SERVICE BULLETIN

APPLICABILITY: 2015-16MY Legacy and Outback Models
2015-16MY WRX Models

NUMBER: 07-106-16
DATE: 02/08/16

SUBJECT: DTC P1C00 / Change to Battery Sensor

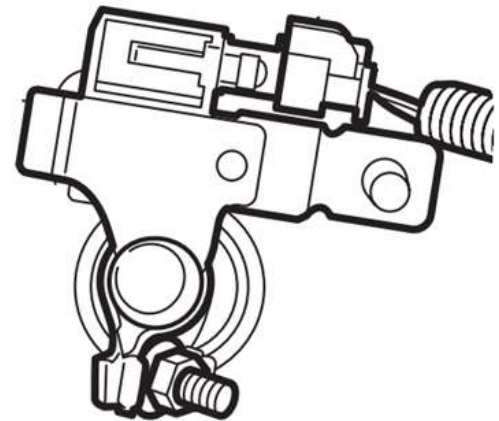
This bulletin announces a change to the battery sensor to prevent unnecessary occurrence of DTC P1C00 being set / stored in the ECM memory.

The new battery sensor was incorporated into production as per the chart below:

Although DTC P1C00 alone does **NOT** cause the Check Engine light to come on, it will likely be found when checking for any stored DTCs in the ECM. If the battery sensor is not replaced after identifying a stored P1C00, it will reset after clearing the memory on the next key cycle. When P1C00 is found in memory of a vehicle built prior to the production change, replace the battery sensor following the procedure in the applicable Service Manual.
